Technical Service Bulletin			
Edition: Final V1	TSB#: 493 (ECR1905)	Issue date: May 26, 2023	Page 1 of 2

Title: Improve capsule kits to avoid cracking the capsule

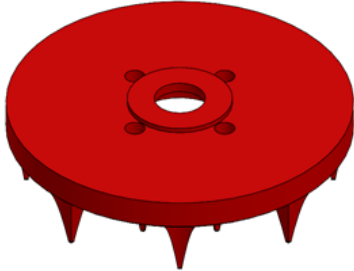
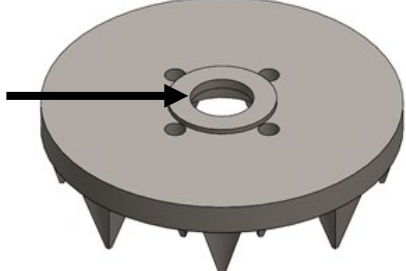
Improve the capsule sprinkler to avoid damaging the capsule while inserting/removing the portafilter.

New capsule sprinkler (PN75200022) IS NOT compatible with the old capsule holder (PN75200063). If you need to replace PN75200063, it is recommended to order the new three parts.

<p>Old Version: 75200011_Capsule_Sprinkler_REV04</p>	<p>New Version: 75200022_Capsule_Sprinkler_REV01</p>

<p>Old Version: 75200063_Drilling_Disc_Capsule_REV03</p>	<p>New Version: 75200074_Drilling_Disc_Capsule_REV01</p>
<p>Internal Ø5</p> 	<p>Internal Ø6</p> 
<p>Old Version: 25096620_Philips_Screw_M5X12 DIN 966</p>	<p>New Version: 25798541_Philips_Screw_M4X10 DIN7985</p>
